Public Comment No. 2220-NFPA 70-2018 [Global Input]

The Correlating Committee directs Panel 15 to review all references to Article 310 under their purview. Article 310 has been divided into Article 310,
 Conductors for General Wiring, and Article 311, Medium Voltage Conductors and Cables for usability and clarity. Panel 15 shall appoint a task group
 to review all necessary references to verify their accuracy and submit Public Comments where necessary. This action instructs Panel 15 to
 submit a Public Comment(s) within the time frame required in the NEC schedule.
 This action shall be considered as a public comment.

Figure Informational Note Figure 517.31(a) Type 1 Essential Electrical System — Minimum Requirement (greater than 150 kVA) for Transfer Switch Arrangement.

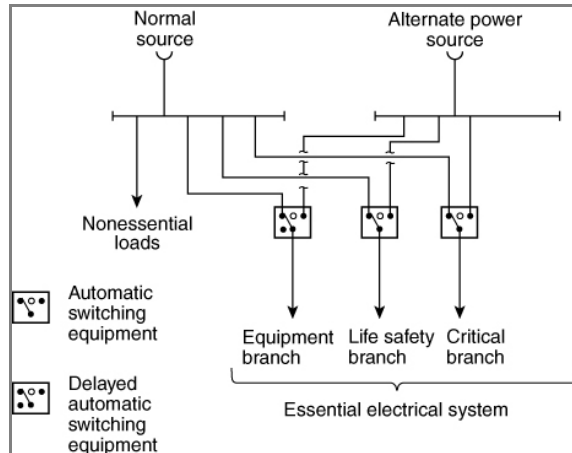
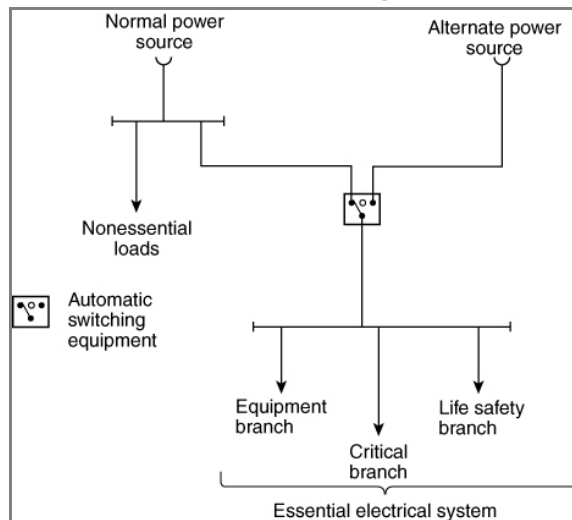
CMP 15 resolved PI 3829. The committee is asked to consider the proposed comment which will add extracted material based on the chair report from the first draft to include language extracted from NFPA 99-2018. Also the committee is asked to consider revised language from PI 3819. This comment should clarify the original intent of the submitter and solve an ongoing problem of interpretation of the code.

Statement: The requirements were reformatted as a numbered list to clarify that these are separate options, based on the system load.

Re: NFPA 70, Article 517.31 (G) Proposed Change

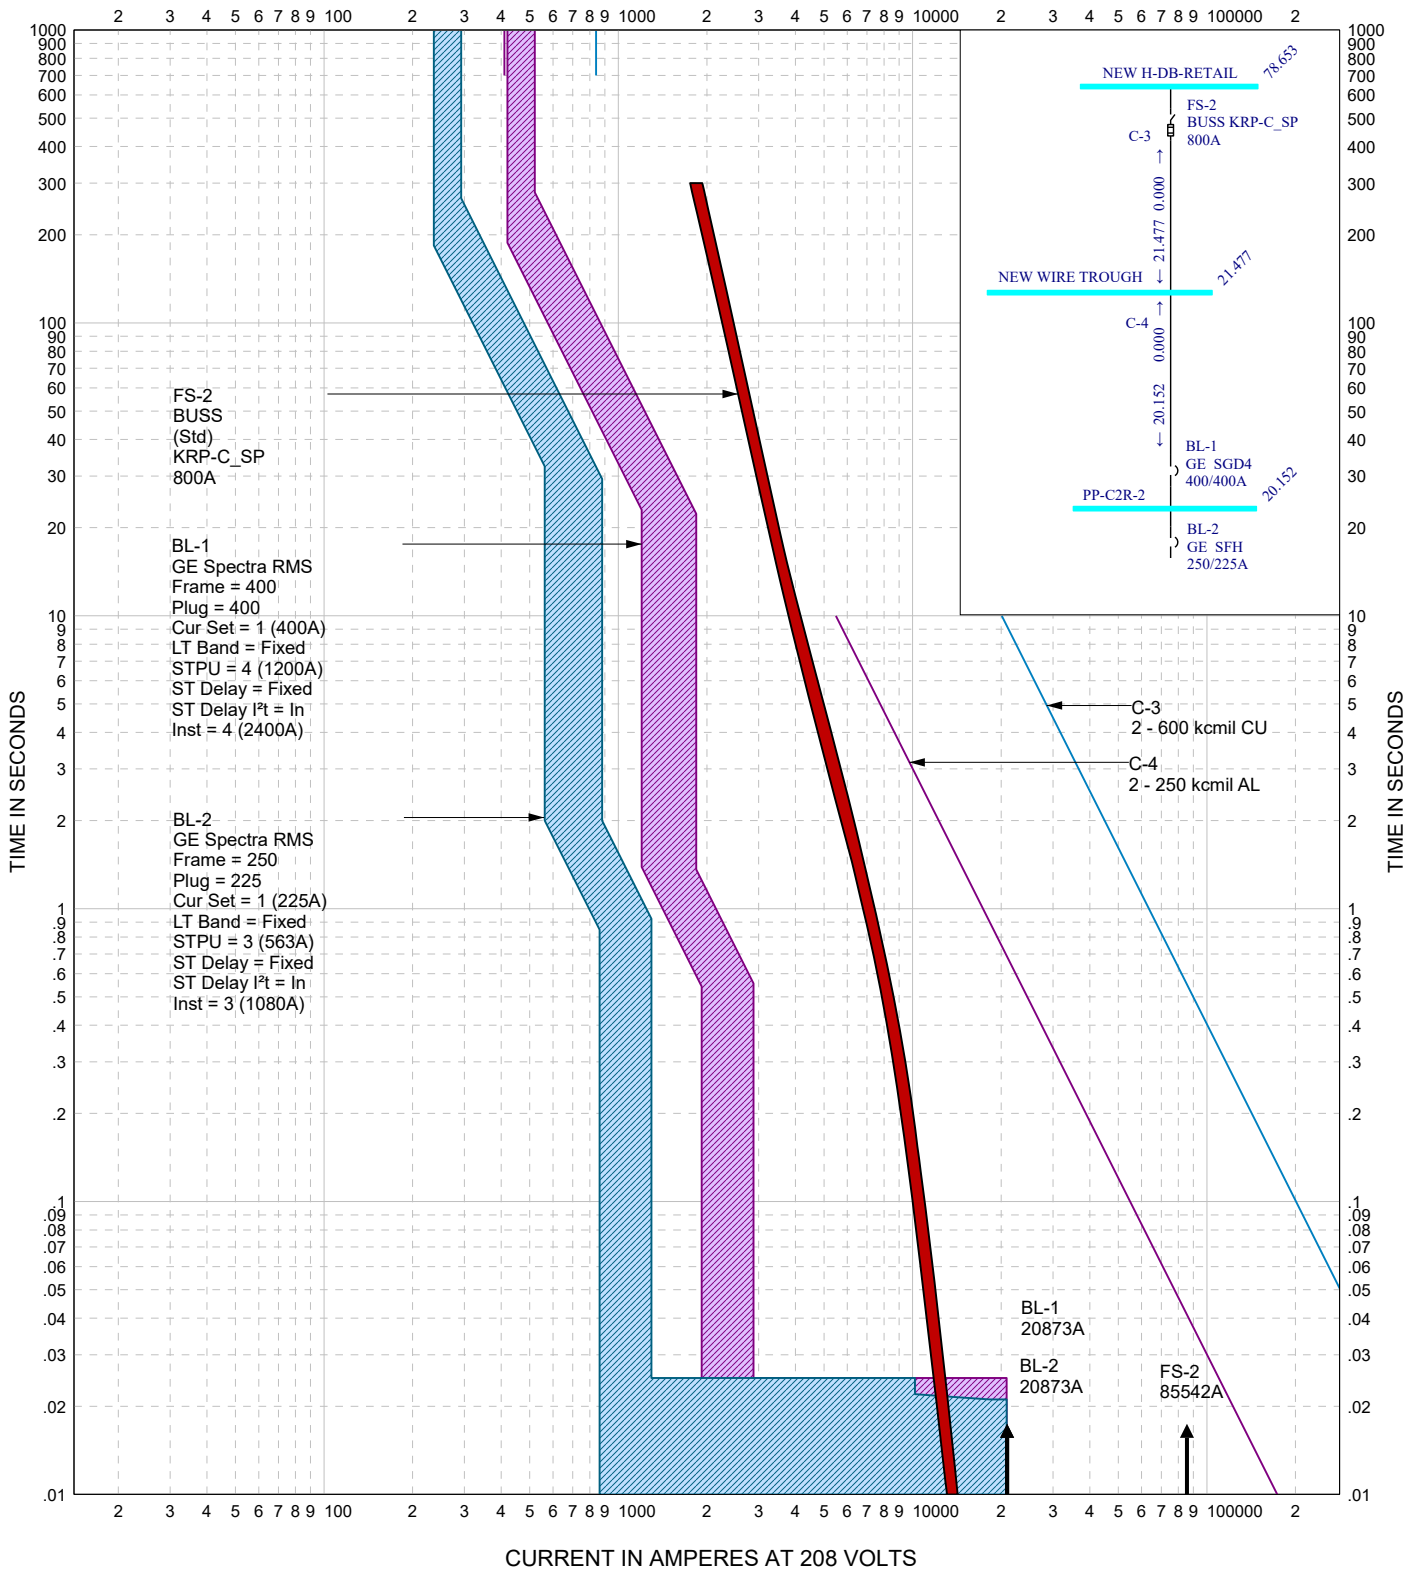
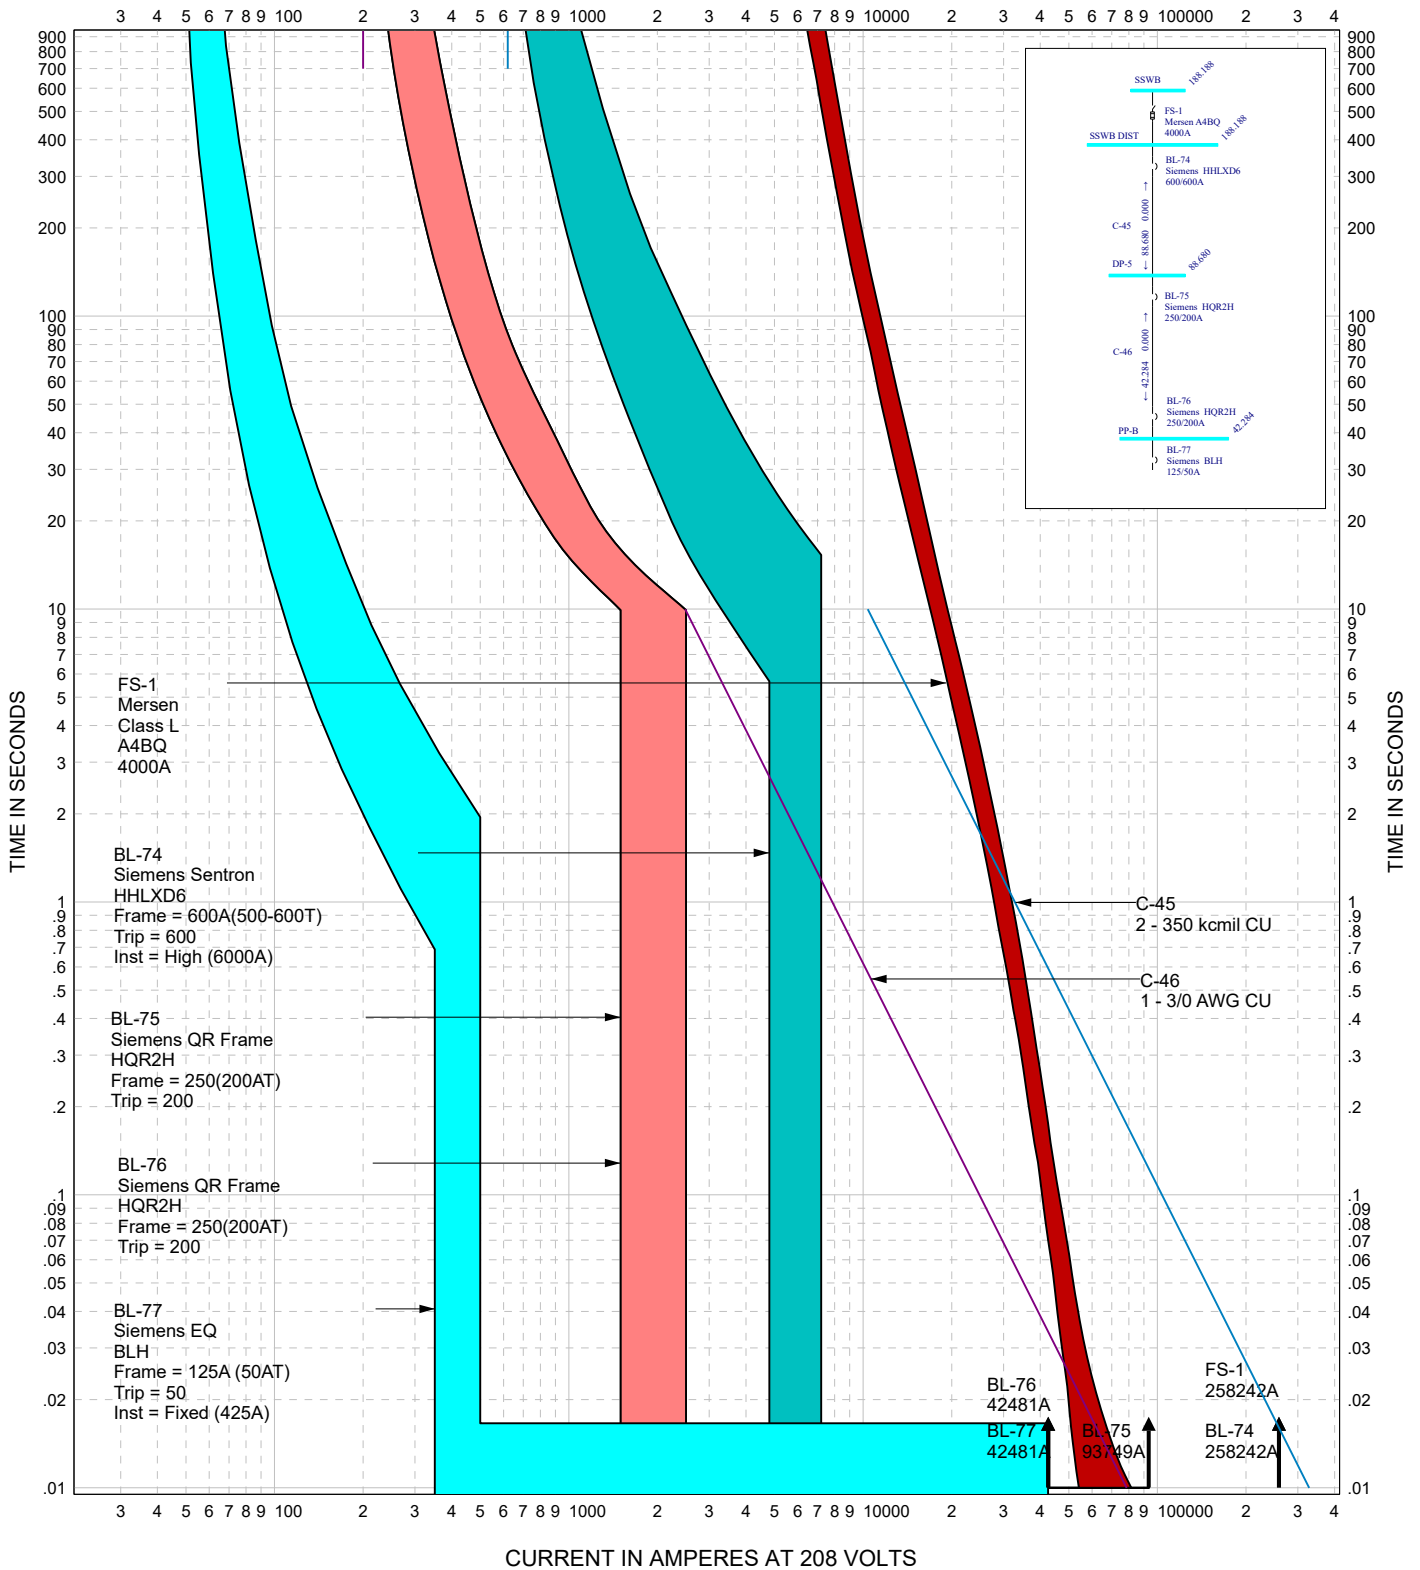
For example, I am showing a few TCC plot's on the next few sheet, and although they appear to have selective coordination below 0.1 seconds, they will in fact in some cases not selectively coordinate if the fault current is greater than the upstream device's instantaneous range, and the whole purpose of adding such requirement of 0.1 sec in the code is a waist and achieves nothing and is misleading to the industry.

According to IEEE papers and many industry experts, the line to ground fault is approximately 50% of the three phase bolted fault current value, and the arcing current is approximately 10% and using those rules of thumbs you can see that in the case of TCC plot labeled PP-C2R-2 one may analyze this and considering all the information may determine that selective coordination has been achieved. However, in the case of TCC plot labeled PP-B although to the average person this may seem to have perfect coordination, its quite the opposite. If a line to ground fault will accrue at the load side of the 125A breaker then it will be approximately $I_{sc}=21kA$ which will cause the upstream 250A breaker to open, which is proven by the manufacturers published TCC plot) thus you will not have selective coordination between them.

If the code making panel believes that selective coordination is absolutely essential to have on these healthcare power systems, then it should be done correctly, either by using the manufacturers published data which indicates selective coordination, or by engineering and analyzing the fault current that may accrue and determine if the downstream device will clear the fault before the upstream device or not.

Resolution: Any changes to the material in the National Electrical Code relating to extracted material from NFPA 99 needs to be changed in that document before a corresponding change can be implemented in the NEC as per Standard Council protocol. The panel suggests the submitter of this public input

pursue changing NFPA 99 in the next cycle and then if successful, resubmit this public input to the NEC.

Figure Informational Note Figure 517.42(a) Type 2 Essential Electrical Systems (Nursing Home and Limited Health Care Facilities) — Minimum Requirement (greater than 150 kVA) for Transfer Switch Arrangement.

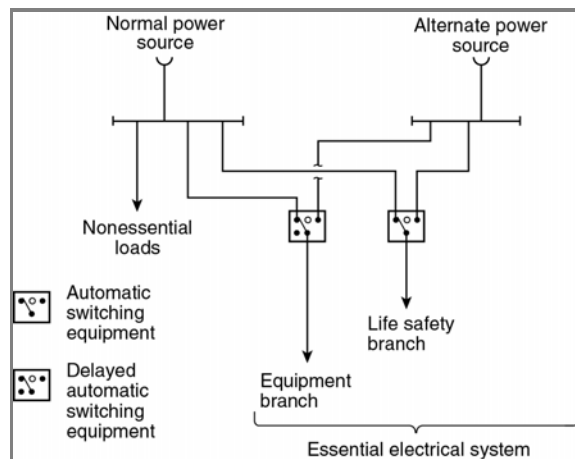
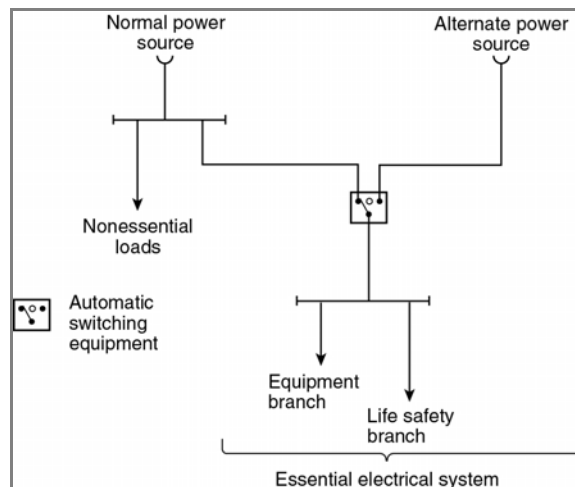
This comment is a accompanying the comment submitted for 517.31(B) clarifying 150kVA and less transfer switch connections. CMP 15 resolved PI 3829. The committee is asked to consider the proposed comment which will add extracted material based on the chair report from the first draft to include language extracted from NFPA 99-2018. Also, the committee is asked to consider revised language from PI 3819. This comment should clarify the original intent of the submitter and solve an ongoing problem of interpretation of the code.
